Access Compliance Report

Public Rights-of-Way

(Curb Ramps)

Intersection ID: 52928	Main Street: GRAY_OAK_LN	Cross Street: MAPLE_OAK_DR	Location: NE
ADA ID: 5BC8C32AE62A	Ramp Type: BlendTrans1	Initial Pass/Fail: Fail	Overall Compliance: No
		Severity Score: 10

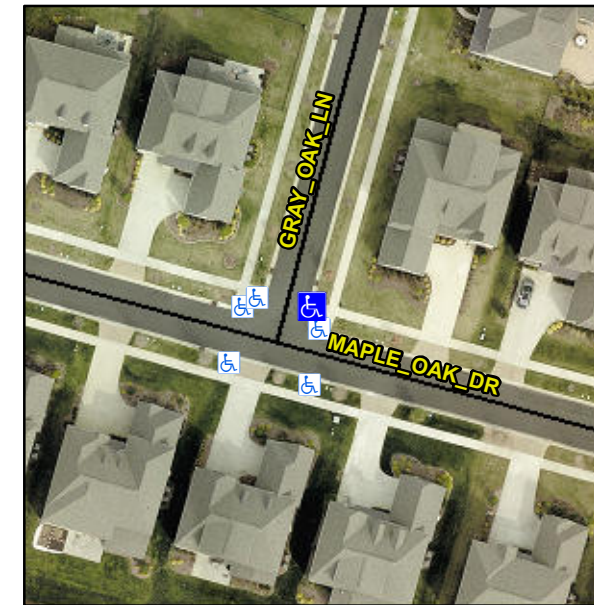
Not Found, R304.5.1, R304.5.3

Compliance	Description	Data	Compliance	Description	Data
N/A	Ramp Length (in)	28.0	Yes	BlendTrans Slope (%)	0.6
No	Ramp Width (in)	46.0	No	BlendTrans XSlope (%)	4.1
N/A	Flare Type LT	N/A	N/A	Flare Type RT	N/A
N/A	Flare Slope LT (%)	N/A	N/A	Flare Slope RT (%)	N/A
N/A	Flare Traversable LT?	N/A	N/A	Flare Traversable RT?	N/A
N/A	Landing Length (in)	N/A	N/A	DWS Provided?	N/A
N/A	Landing Width (in)	N/A	N/A	DWS Contrast?	N/A
N/A	Landing Slope (%)	N/A	N/A	DWS Length (in)	N/A
N/A	Landing X Slope (%)	N/A	N/A	DWS Full Width?	N/A
N/A	Landing Curb? (Y/N)	N/A	N/A	DWS Offset (in)	N/A
N/A	Shared Landing?	N/A			
N/A	Gutter Ponding?	N/A	N/A	Gutter Slope (%)	N/A
N/A	Gutter Lip Ht (in)	N/A	N/A	Gutter X Slope (%)	N/A
N/A	Painted X Walk1?	No	N/A	Painted X Walk2?	N/A
	X Walk 1 Direction	To W		X Walk 2 Direction	N/A
	X Walk 1 Width (in)	N/A		X Walk 2 Width (in)	N/A
	X Walk 1 Slope (%)	2.8		X Walk 2 Slope (%)	N/A
	X Walk 1 X Slope (%)	1.5		X Walk 2 X Slope (%)	N/A

Remove & Replace Curb Ramp With Two New Directional Ramps or Equivalent.
